Cylinder Head Main Wiring Harness Interference
Models: MY '09 Monster 696
Recall Bulletin RCL-09-001

NHTSA Campaign I.D. Number: 09V-142
Transport Canada Safety Recall I.D. Number: 09-089

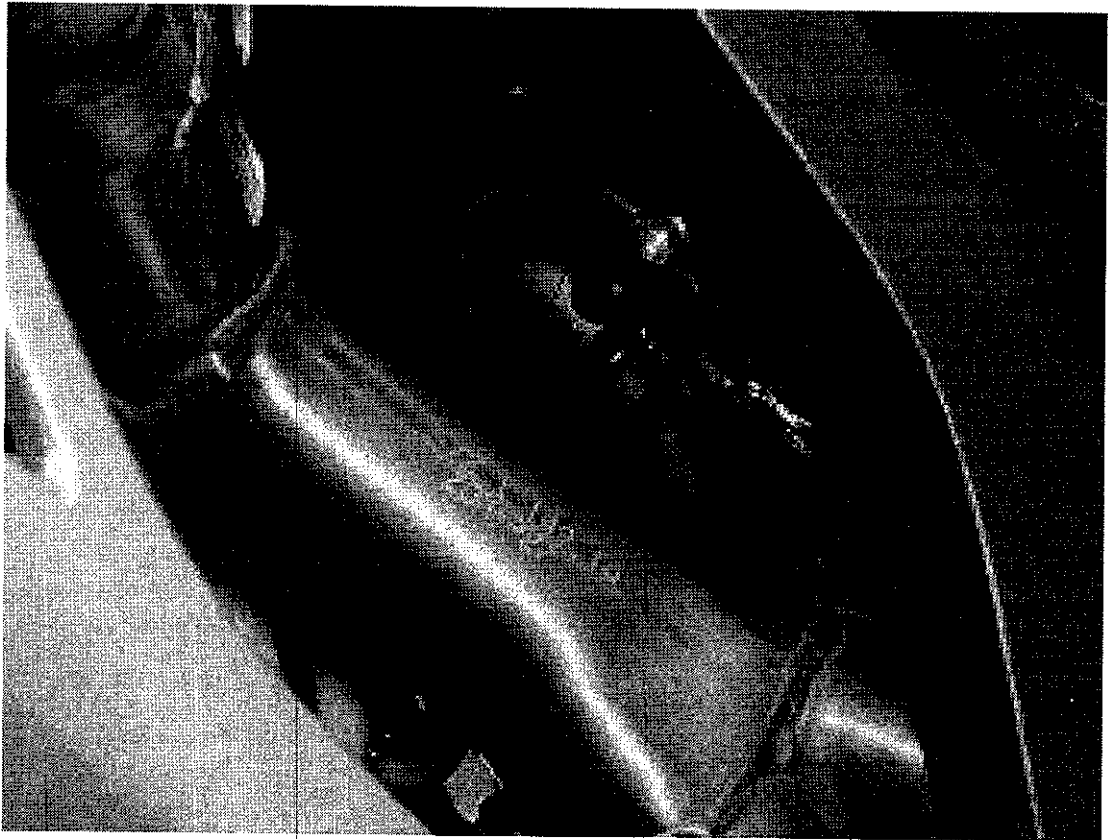
Check the vertical cylinder lambda sensor power cable as it could touch the vertical cylinder exhaust pipe if not correctly positioned. Fasten the cable, as shown, to the fuel pump flange cover retainer by means of a cable tie.
